PCN Number: 0625

PCN Change Level: Minor

Subject: Routed Clock Timing on Axcelerator[®] and RTAX-S

Figure 1 • Figure 1: AX Routed Clock Half-Tile Row (HTR) Architecture

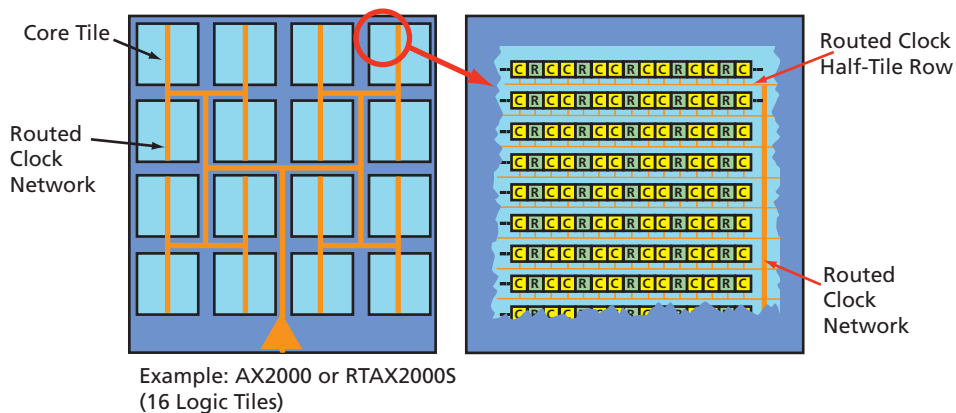
In the AX and RTAX-S architecture, each device is comprised of core tiles. For example, an AX2000 or RTAX2000S device includes 16 core tiles in a 4x4 array. Each core tile is served by four routed clock segments, which run along the middle of the core tile. Logic modules, I/O cells, and SRAM cells are served by ribs branching off the central routed clock segments. Each of these ribs is called a routed clock half-tile row (HTR). See Figure 1 for more information.

The maximum number of loads that any HTR can serve is 44. The loads are separated into the following groups:

In order to exceed 16 loads, the HTR must be connected to loads other than just R-cells. In almost all designs, the number of loads applied to each HTR is less than 16. The SmartTime timer provides an accurate assessment of CLK delay if the load on each HTR is 16 or less. However, if the load applied to an HTR exceeds 16, then the CLK delay will be slightly underestimated by the SmartTime tool. The degree to which SmartTime underestimates the CLK delay is dependent on operating temperature, device speed grade, and the actual number of loads on the HTR, but it is not worse than 1.1 ns. Table 1 lists the data. Actel has observed only one customer design where an HTR exceeded 16 loads. This design was targeted to a commercial Axcelerator FPGA.

Actel has made changes to the timing models in the SmartTime tool and has also made changes in how Axcelerator and RTAX-S designs are compiled. These changes eliminate the problem, and were introduced in Designer v7.2 SP1. New designs and existing designs are handled differently and are described in the following sections.

Designer v7.2 SP1 will limit the fanout of the CLK network to a maximum of 16 loads per HTR, when at least 1 R-cell clock pin is connected to the HTR. If no R-cell clock pin is connected to the HTR, then the fanout limit will not be applied. The software will assume that the loads are purely combinatorial and are not sensitive to clock skew on the routed clock.

When Designer v7.2 SP1 or later encounters a design created with a previous version of Designer software, and if the design has an HTR load greater than 16, it will print a warning in the log file, stating that the HTR loading maximum has been exceeded. The timing of the HTR with loading greater than 16 will be amended to reflect the updated timing models in v7.2 SP1, in accordance with table 1 in this document. Designer v7.2 SP1 will not make any place-and-route changes to eliminate any HTR loads greater than 16.
